SERVICE INFORMATION NO. SI 20-031

BRP-Rotax MSB-912-054

SERVICE BULLETIN
CHECKING OR REPLACEMENT
OF FLEXIBLE FUEL LINE
FOR ROTAX® ENGINE TYPE 912 (SERIES)
SB-912-054

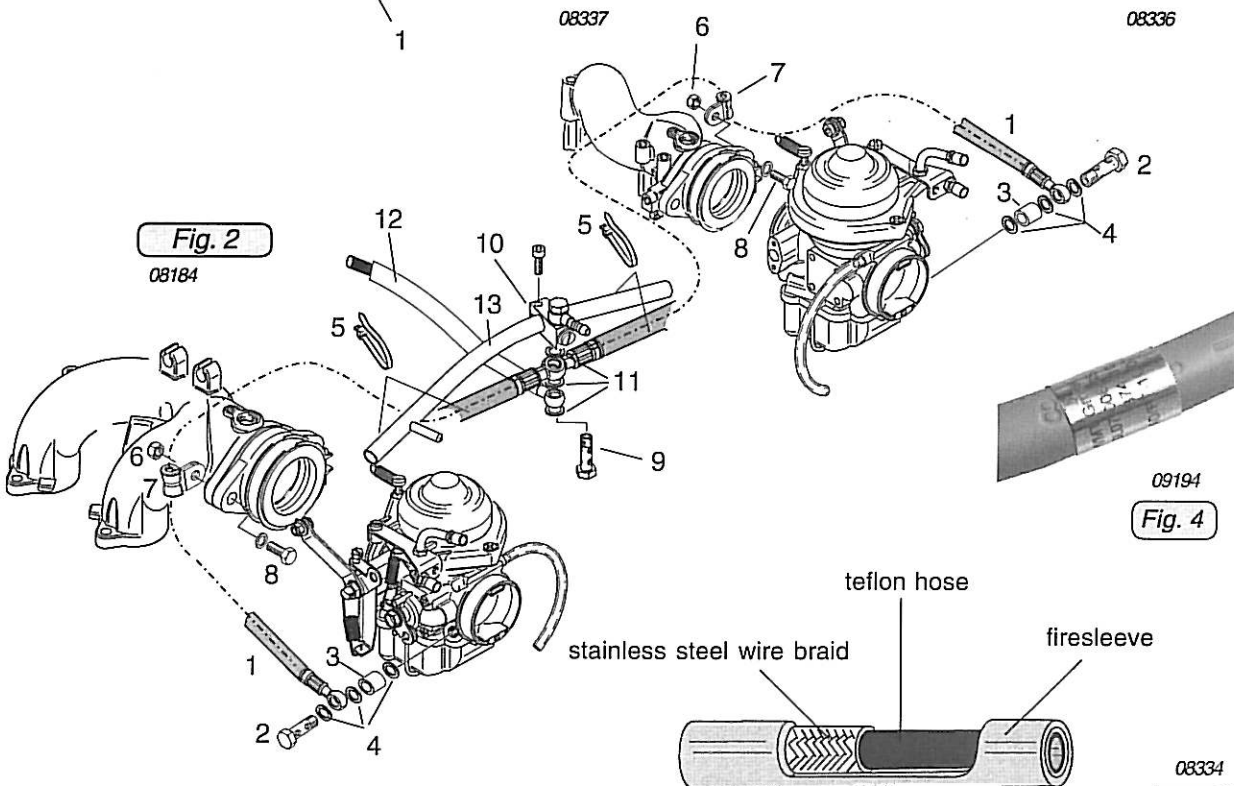
Visual inspection of the fuel line (1) in the area clamp (7) and both ends of the yellow protection cover. (see Fig. 1)

◆ **NOTE:** A possible crack can be observed by careful bending of the fuel line. If you notice cracks or porosity then you need to replace the fuel line in accordance section 3.1.2.

2. Install both cable clamp (7) in accordance with Fig.1 on the fuel line.

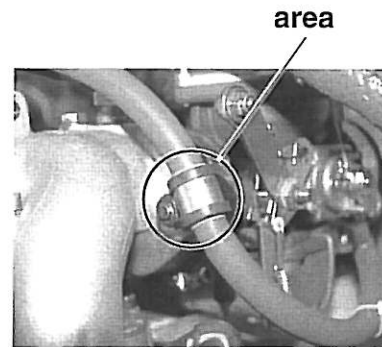
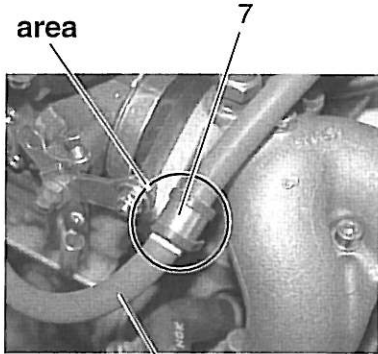
Due to a chemical reaction of the adhesive (in the area of the yellow position marks on the firesleeve) porosity and/or cracks on the firesleeve can occur.

Fuel leakage within this area is not an issue, as only the fireproof protection hose is affected and the fuel is routed in a wire braid reinforced teflon hose.

◆ NOTE: The relevant part number and S/N of the fuel line is attached and/or evident on the metal tag on the hose (see Fig. 4).
